FINAL PLAT THE TRAILS FILING No. 10

A SUBDIVISION OF PORTIONS OF THE SOUTHWEST QUARTER OF SECTION 16 AND THE SOUTHEAST QUARTER OF SECTION 17,
TOWNSHIP 12 SOUTH, RANGE 64 WEST OF THE THE SIXTH PRINCIPAL MERIDIAN, COUNTY OF EL PASO, STATE OF COLORADO.

Sheet 2 of 4

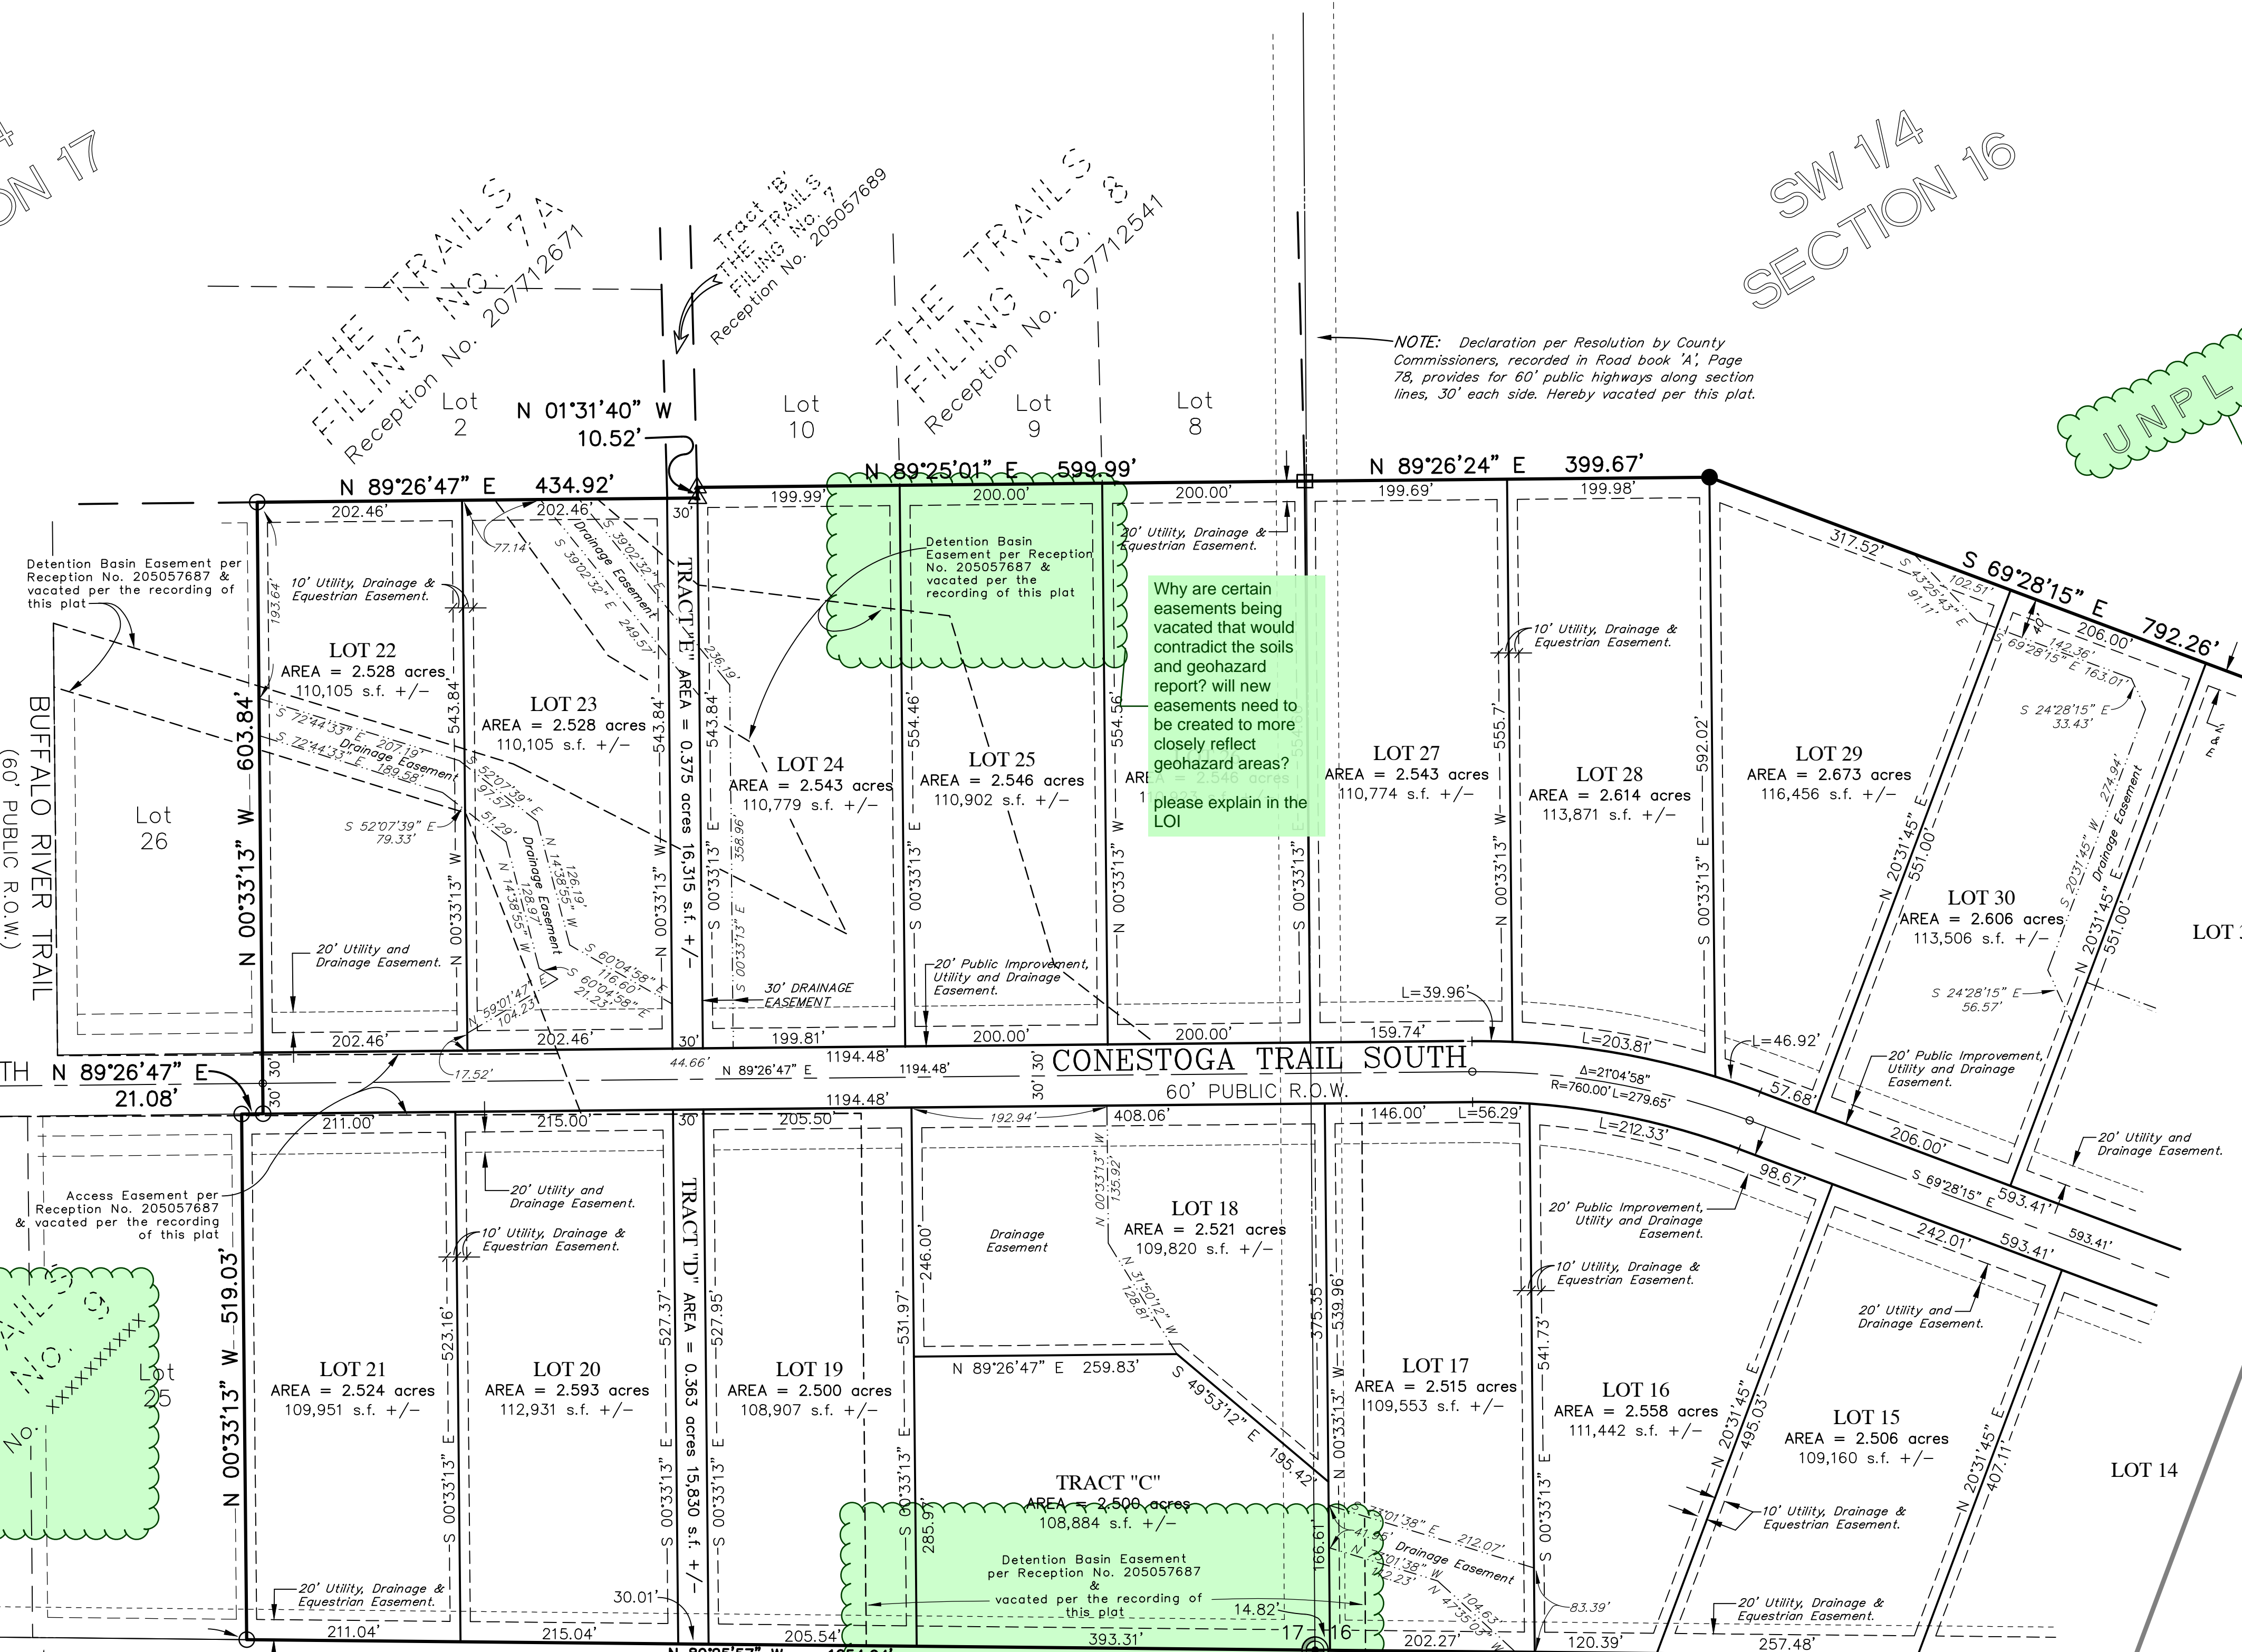
Will there be hydrants or cisterns? If cisterns, an easement is required.

Add reception number

Anything depicted on the plat being parcels or other lots, shall be depicted with a dotted line and have "Not a part of this subdivision" labeled on it

Why are certain easements being vacated that would contradict the soils and geohazard report? will new easements need to be created to more closely reflect geohazard areas? please explain in the LOI

A plat note should be added referring to this and what is being vacated via this plat

Sheet 3 of 4

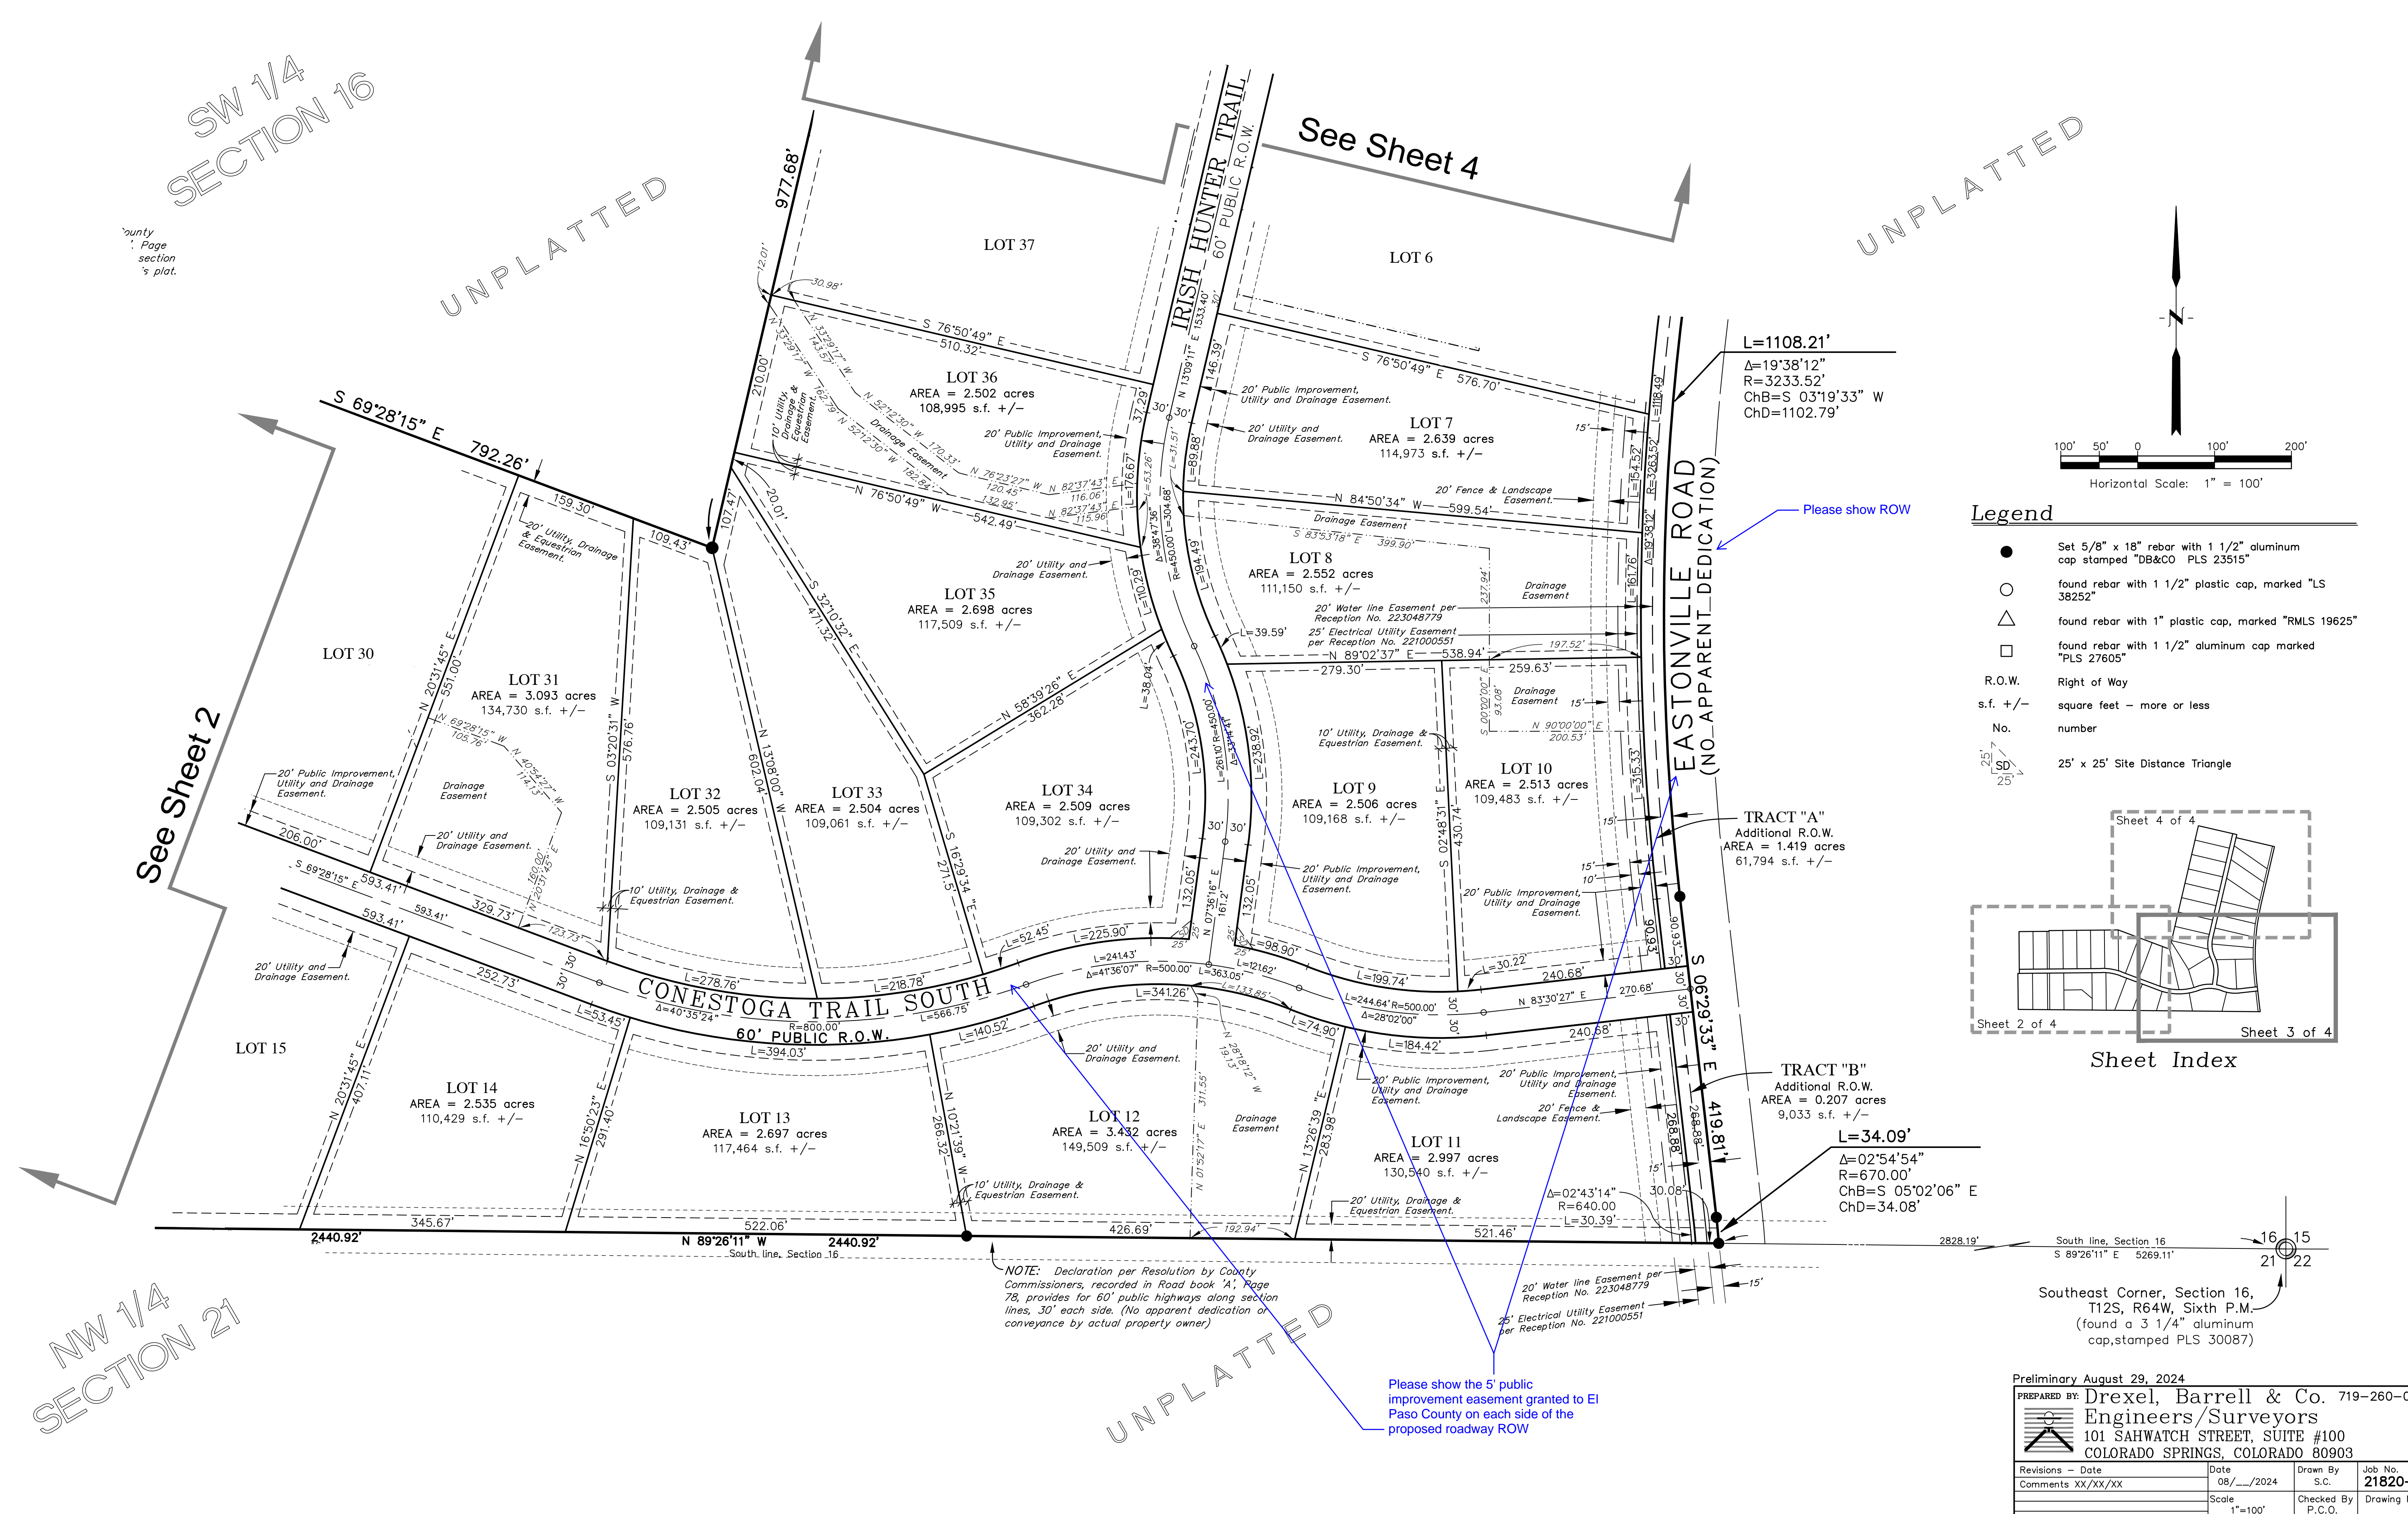
Please show the 5' public improvement easement granted to El Paso County on each side of the proposed roadway ROW

Sheet 4 of 4

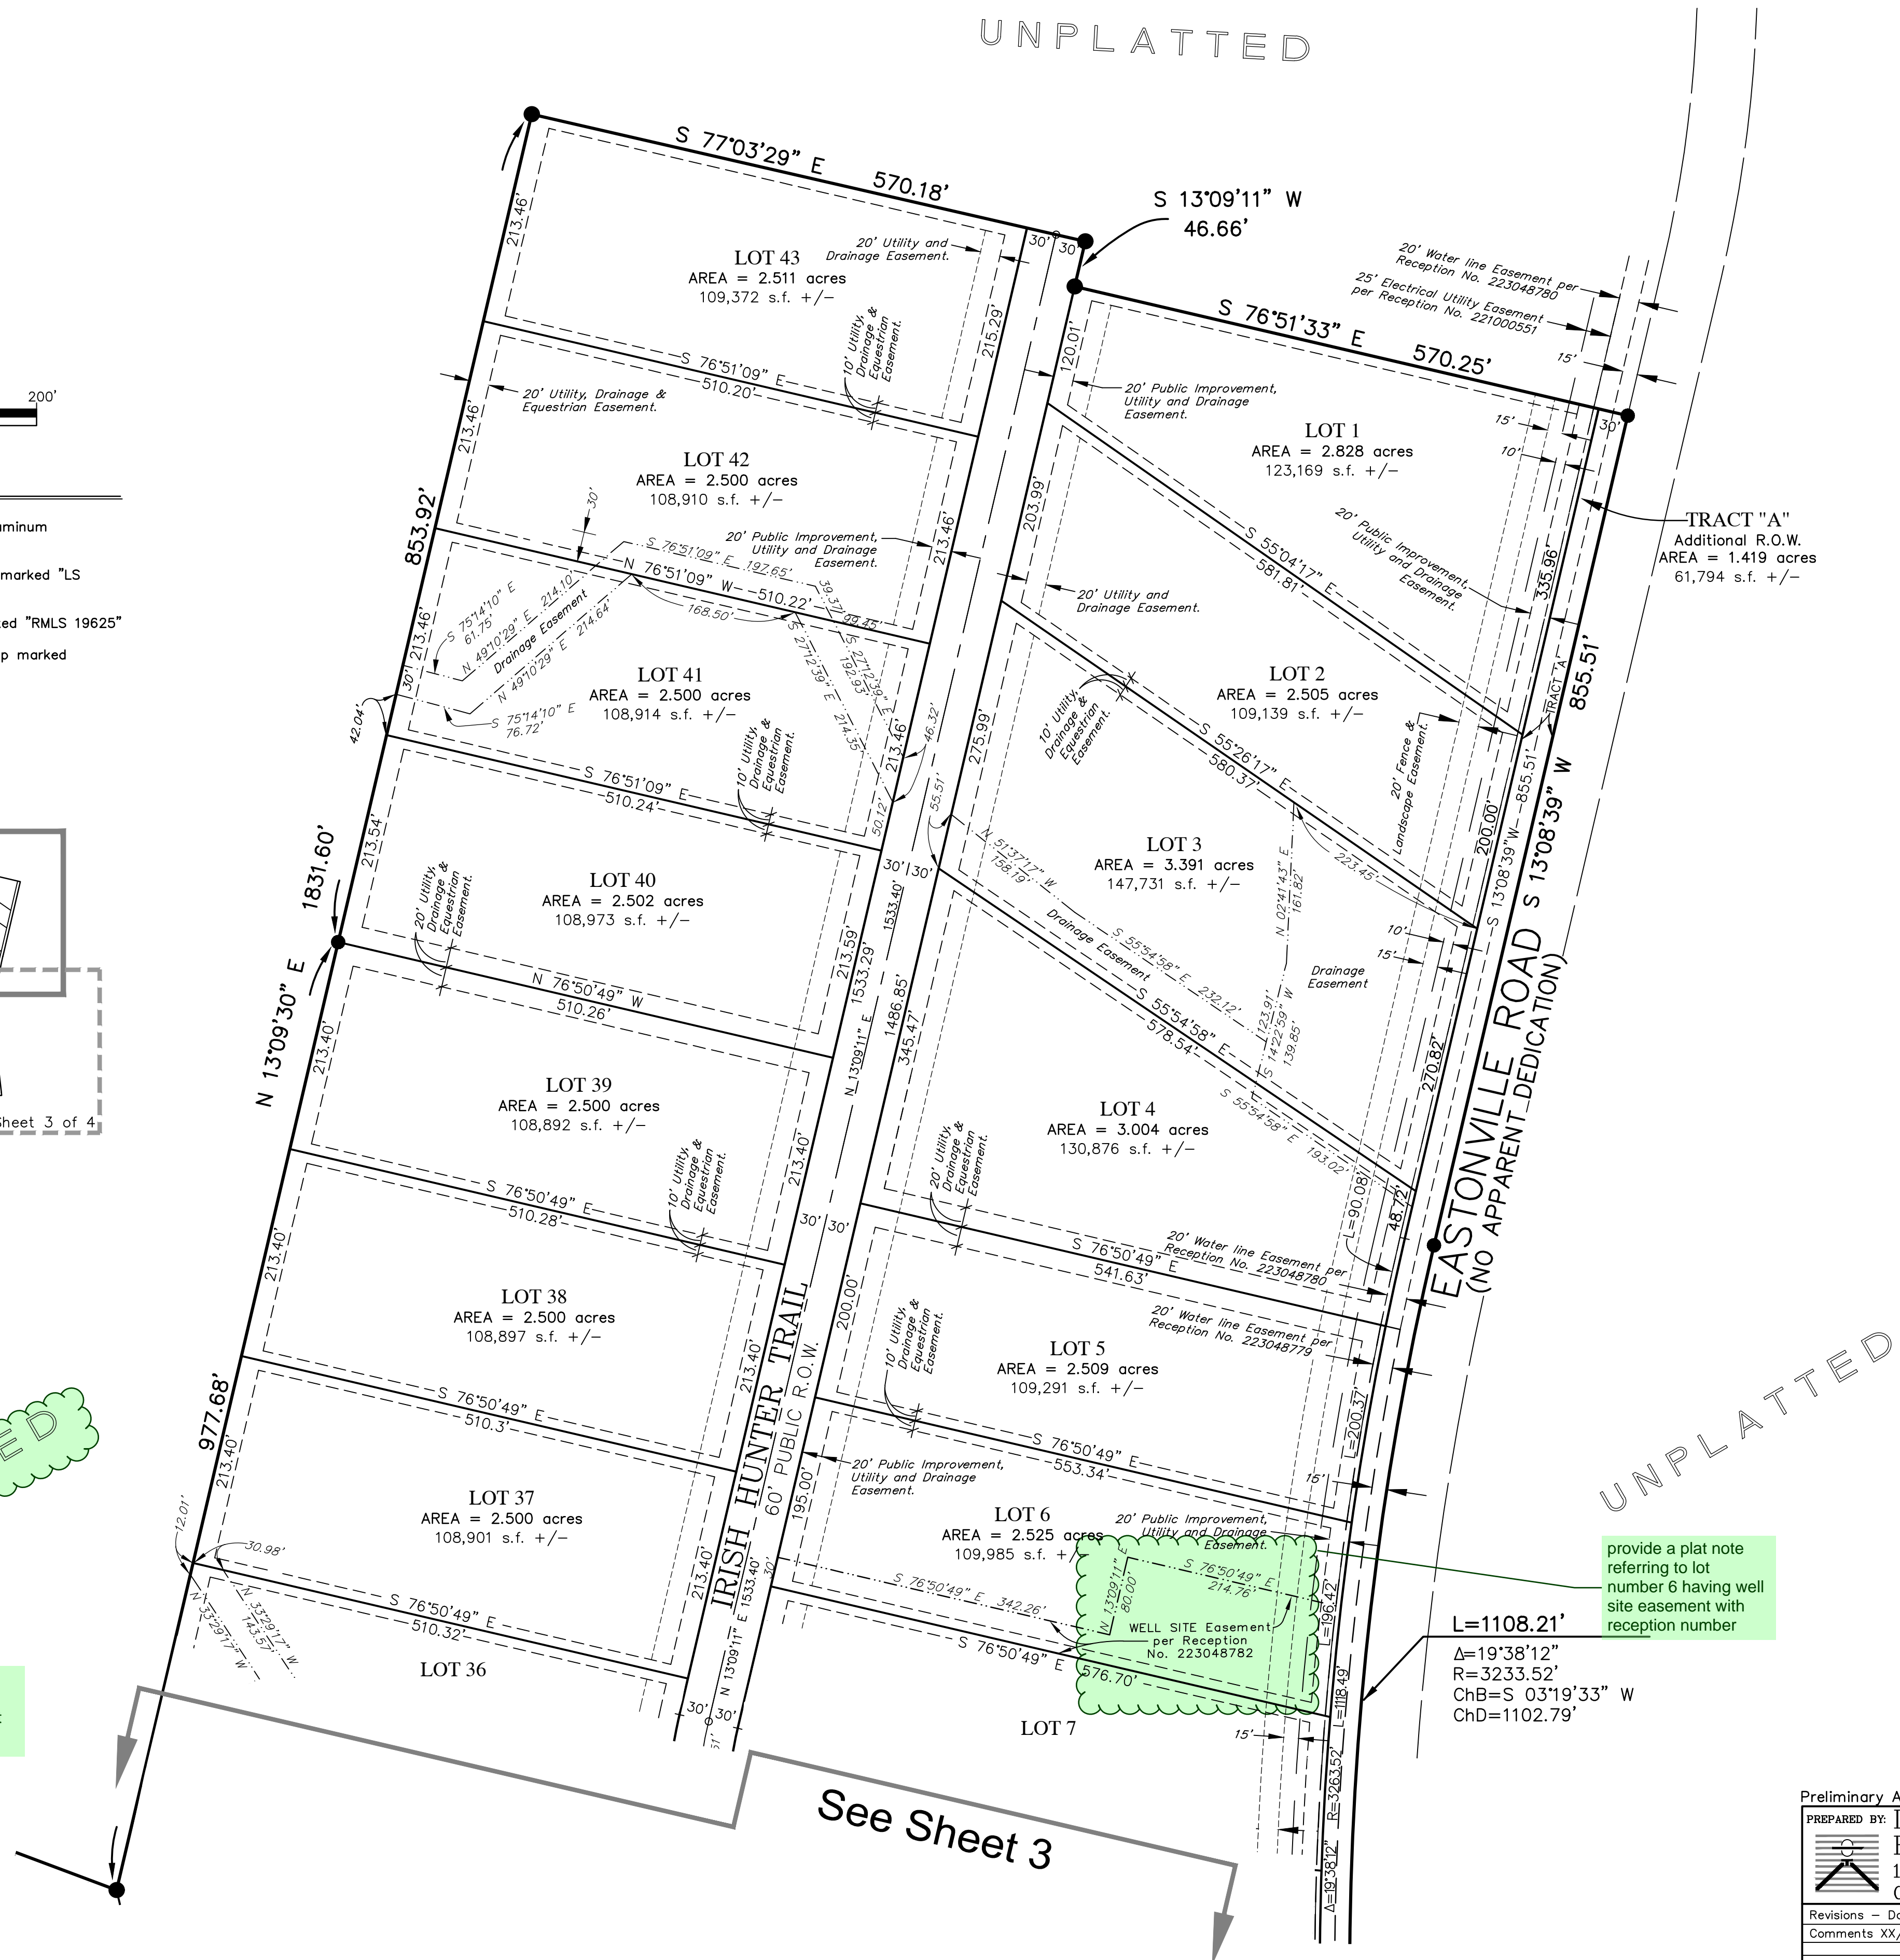
Anything depicted on the plat being parcels or other lots, shall be depicted with a dotted line and have "Not a part of this subdivision" labeled on it
